Product Change Notice

Issue Date: 13-December-2021

0.56" Dual Digit Scrambler poles modification for Leadframe Seven Segment Display

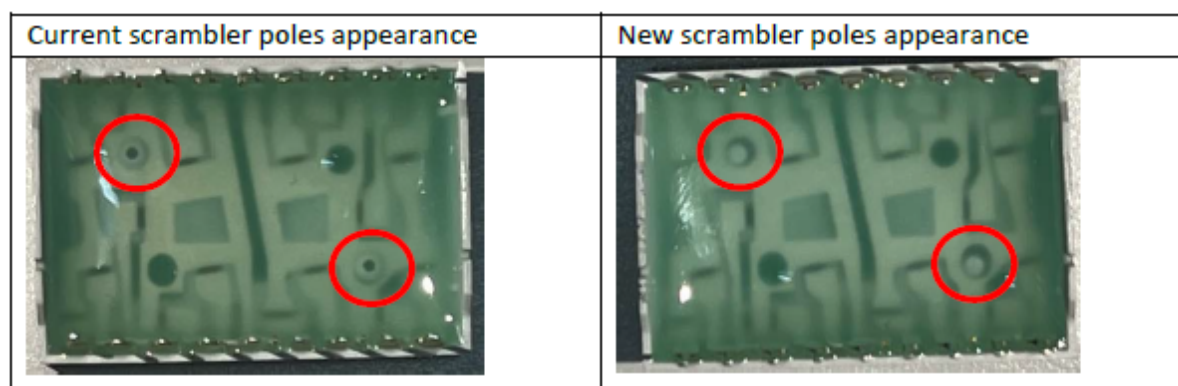
The new scrambler will replace current scrambler for part numbers above.

Improve the strength of scrambler poles.

There is no change in fit and function of the product as per datasheet. However, there is a minor scrambler poles appearance change as illustrated below.
